Item Name: 205 Skidtube bent detail

DRAWING NO. D2580	TITLE 205 SKIDTUBE ASSEMBLY	REV. D	DART AEROSPACE LTD ENGINEERING ORDER		D.E.O. NO. D2580-D-1	SHEET NO. SHEET 1 OF 1	SCALE NTS
DRAWN <i>UP</i>	CHECKED <i>L</i>	MFG. APPR. <i>R</i>	APPROVED <i>MP</i>		DE APPR. <i>MP</i>		
DATE 10.09.22	DATE 10.11.04	DATE 10.11.04	DATE 10/11/04		DATE 10.11.04

PURPOSE:

CHANGE ALL WELDED CROSSBOLT SPACERS TO SWAGED SPACERS

SECTION D-D & SECTION H-H ARE AMENDED AS FOLLOWS:

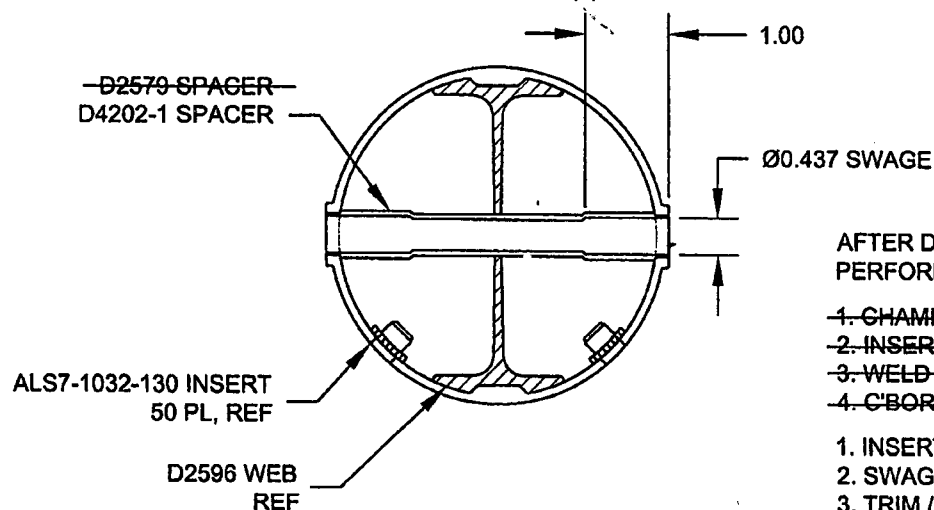
AFTER DRILLING AND BENDING ASSEMBLY
PERFORM THE FOLLOWING FOR Ø0.508 HOLES ONLY:

1. CHAMFER HOLE 0.050 X 45°
2. INSERT D2579 SPACER (20 PLACES)
3. WELD INTO PLACE AND GRIND FLUSH
4. C'BORE D2579 SPACER TO Ø0.437 X 1.00 DEEP

1. INSERT D4202-1 SPACER, 20 PL (-041) OR 24 PL (-045)
2. SWAGE TO Ø0.437 X 1.00 DEEP PER QSI 002
3. TRIM / GRIND FLUSH PER QSI 002
